December 8, 1994
LD-94-069

Subject: System 80+™ Design Control Document Design Change

During the development of the Design Control Document, ABB-CE proposed a design change to remove the reactor coolant pump seal coolers. These coolers are shown as "Cooler No. 1" and "Cooler No. 2" on CESSAR-DC Figure 5.1.2-2. The high pressure cooler, also shown on that figure, remains as part of the design. Seal coolers No. 1 and 2 are being removed to simplify the design and it is noted that their removal decreases the probability of an intersystem LOCA.

Figure
18.7.3-21

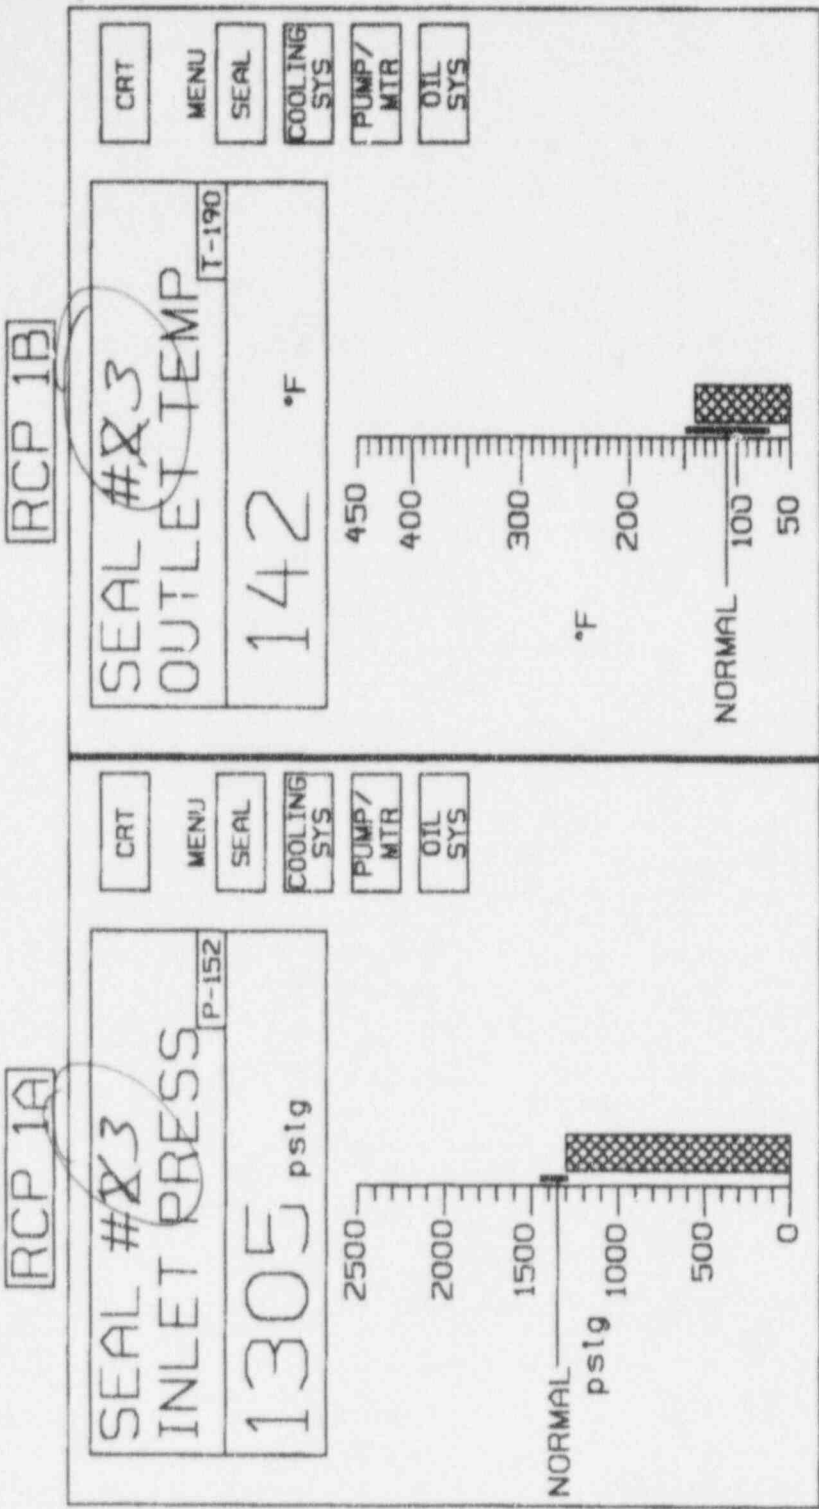
Delete
